Contract No. T201107306.01
Federal Aid Project No. EBROS-S466(01)
BR 3-368 ON SYCAMORE ROAD OVER ELLIOTT BRANCH
Sussex County

Enclosed is Addendum No. 4 for the referenced contract consisting of the following:

Questions and Answers since Addendum No. 2:

TYPICAL SECTION

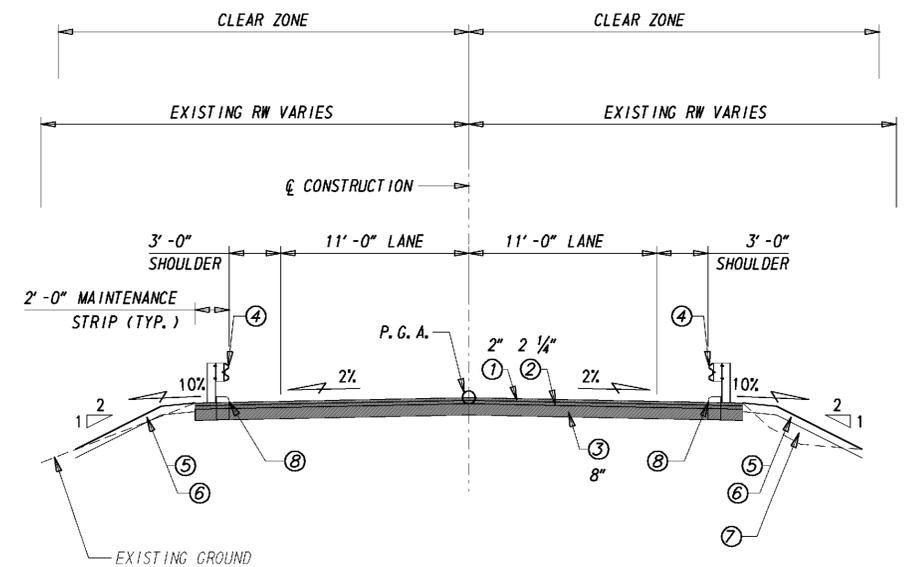
5. The typical section on sheet 3 of 13 shows several items that are not included in the contract (209006 Borrow Type "F", 701012 Portland Cement Concrete Curb, Type 1-4, 720050 Galvanized Steel Beam Guardrail). Please clarify.

Typically F Borrow would be used here, but because the quantity will be so low, we are changing this item to Item 209003, Borrow Type C. This will be reflected in the plans in Addendum #4. Item 701012 will be added in Addendum #4. Item 720050 was changed to Item 720043 in Addendum #2, and this will be reflected in the typical section legend in Addendum #4.

△ ITEM #720043 - GALVANIZED STEEL BEAM GUARDRAIL, TYPE 1-27

△ ITEM #209003 - BORROW TYPE 'C'

ADDENDUMS / REVISIONS	
△ REVISED ITEM NUMBER AND DESCRIPTION	6/8/12 - JPN

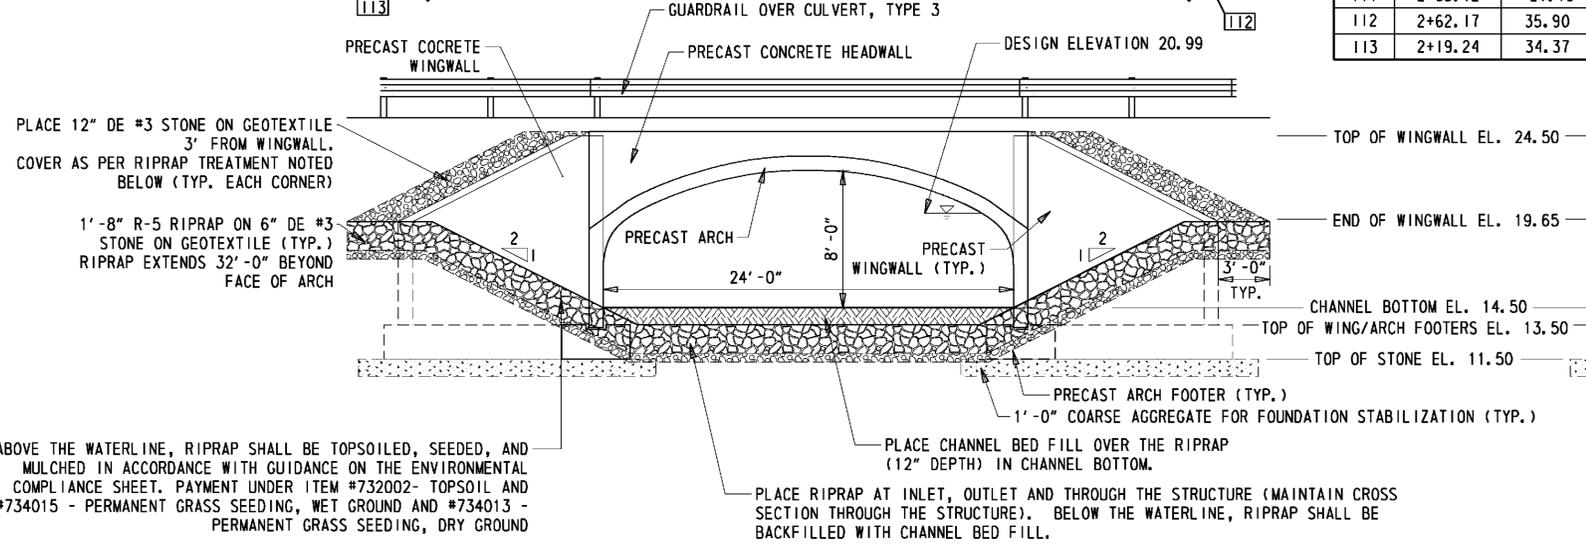
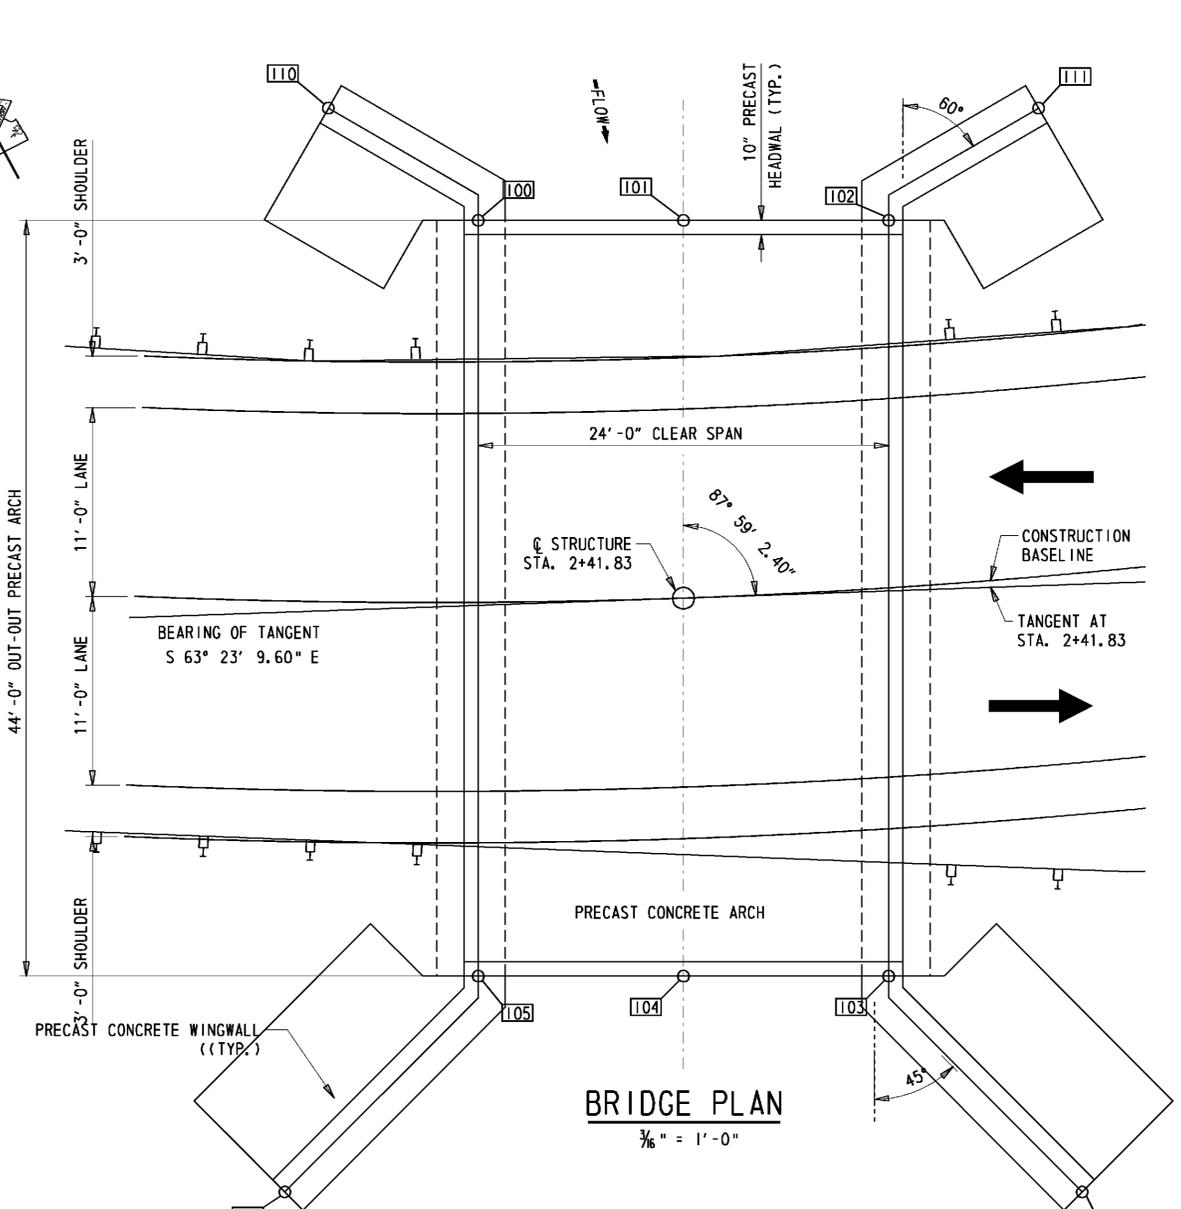
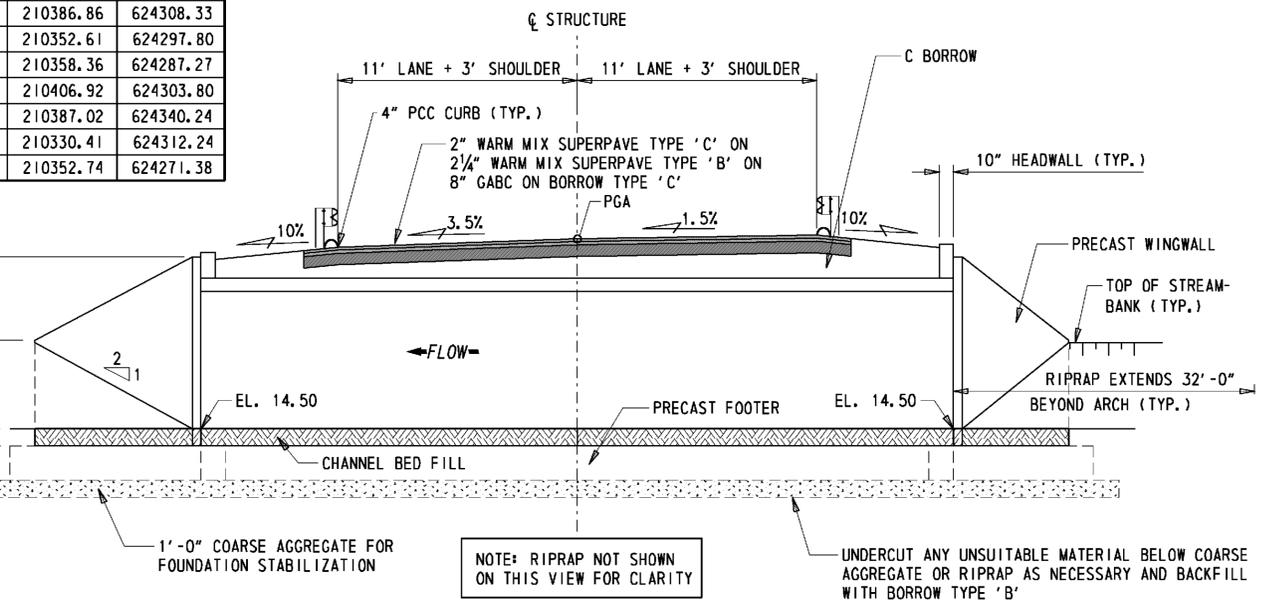
1. The bid plans for this project call out a 4.0 TSF "allowable bearing capacity". This terminology seems to indicate an LFD geotechnical parameter for an LFD foundation design.

However, the bridge specifications call out HL-93 design live load and LRFD design. Can you please clarify whether the foundations should be designed per LFD or LRFD?

If the foundations should be designed LRFD, can you please provide the ultimate bearing

resistance, and the factored bearing resistance for design of the foundations? Could you also provide a copy of the geotechnical report and/or calculations for the ultimate bearing resistance value?

The 4.0 TSF is the Factored Bearing Resistance, calculated with LRFD. The Nominal Bearing Resistance is 11.5 TSF. "Allowable" bearing capacity, as seen on the plans, is incorrect ASD terminology, and should have read "Factored Bearing Resistance" (a typo, as the 4.0 TSF was done in LRFD, not ASD). The foundation design should be done using LRFD.

- ~~ALLOWABLE BEARING PRESSURE -
ALLOWABLE BEARING PRESSURE NOT TO EXCEED 4.0 TSF FOR ALL ELEMENTS.~~
- FACTORED BEARING RESISTANCE
FACTORED BEARING RESISTANCE NOT TO EXCEED 4.0 TSF FOR ALL ELEMENTS.
